THE CORPORATION OF THE DISTRICT OF BURNABY

Report of the Advisory Planning Commission

1. Kingsway/Edmonds Area Plan

PLANNING DEPARTMENT
1980 January 08
Our File: 15.148 "0"

SKETCH 1

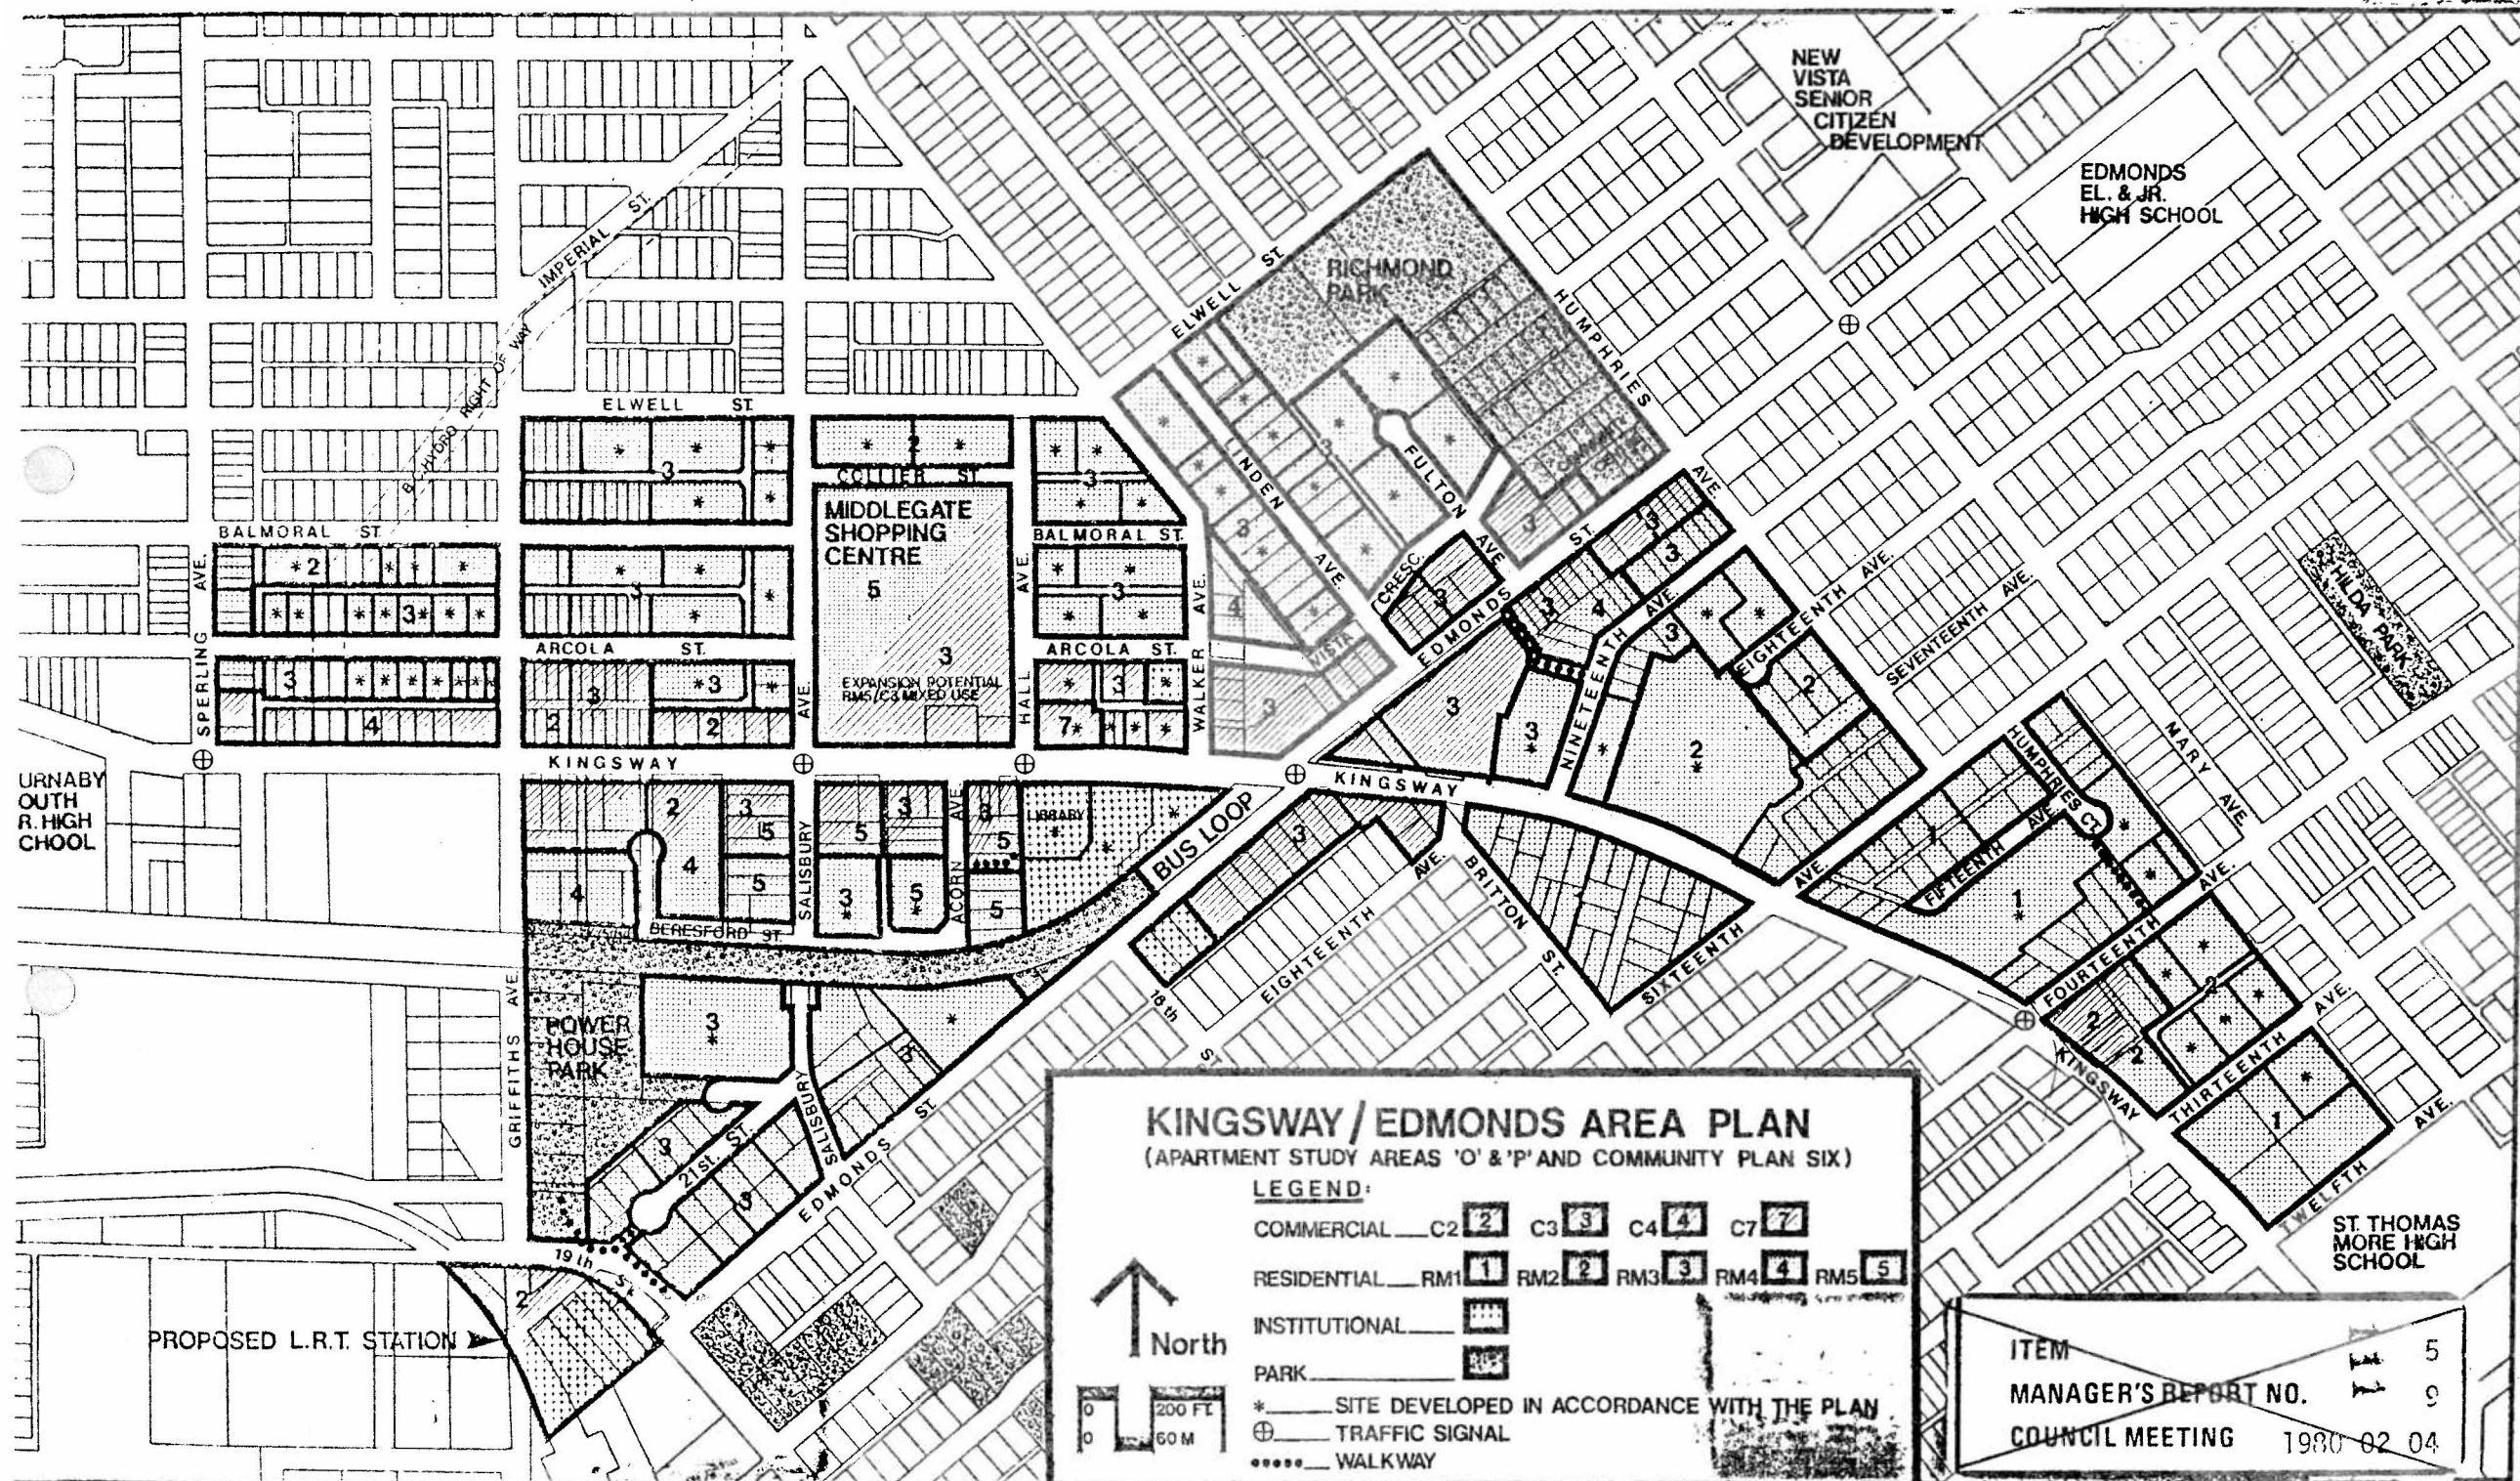
- a) "THAT Council adopt the Kingsway/Edmonds Area Plan as illustrated on sketch 1 of Manager's Report No. 9, Item 5 and described in the Report entitled Kingsway/Edmonds Area Plan with the amended park trail connection to Powerhouse Park as illustrated on the Planning Department Design Sketch with the following additional considerations:

- i) That further consideration be given to constructing Beresford Street west to Griffiths Avenue with the retention of the trees within the current road allowance being incorporated into the park strip.

- iv) That the area south of Edmonds Street to 18th Avenue, from 19th Street east to the Safeway parking lot (Kingsway) be included in the Kingsway/Edmonds Area Plan and designated as a buffer zone in the form of RM2 low rise apartment development.

We have reviewed Mr. McAtee's proposal related to providing a cul-de-sac on Twenty-first Street at Nineteenth Street.

As Nineteenth Street is to form a portion of a secondary arterial in accordance with the approved Conceptual Transportation Plan, the idea of the cul-de-sac has merit. Upon construction of the cul-de-sac, traffic will leave the residential area via Salisbury (a local street) to Edmonds (a collector). This relationship of roads is in keeping with the relationship outlined on page 22 of A Comprehensive Transportation Plan for Burnaby. Such a road pattern will eliminate ingress and egress from this residential enclave at a potentially dangerous location on a secondary arterial between two intersections.

It is proposed that the cul-de-sac be located approximately one hundred twenty feet back from the Nineteenth Street road allowance to avoid building an unnecessary length of road. Thirty-three feet of the redundant road allowance will be provided to the site to the north while the southerly thirty-three feet will be retained for a public walkway and fire truck access if needed by the Fire Department. Access from the park-trail system south of Edmonds Street to Powerhouse Park will be accommodated by a sidewalk on Nineteenth Street which is separated from the road by a planted boulevard (see attached Sketch #1).

AMENDED PARK - TRAIL CONNECTION TO
POWERHOUSE PARK. - PLANNING DEPARTMENT
DESIGN SKETCH.

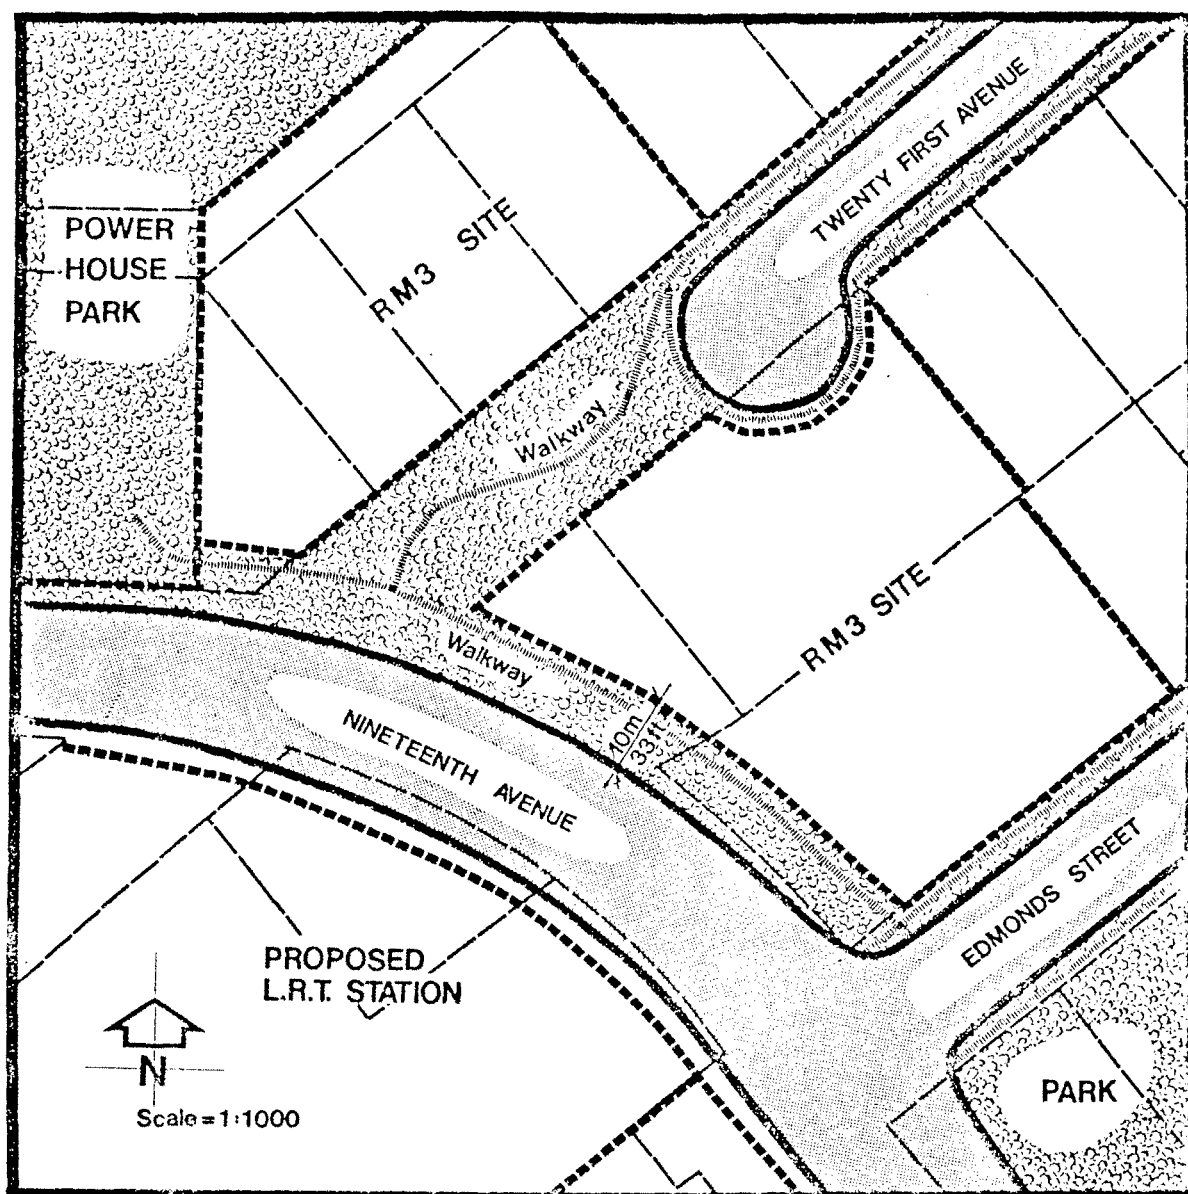
Attached to this report, for the information of Council, is a copy of Sketch 1 of the Municipal Manager's Report No. 9, Item 5 with the amended park trail connection to Powerhouse Park as illustrated on the Planning Department design sketch.
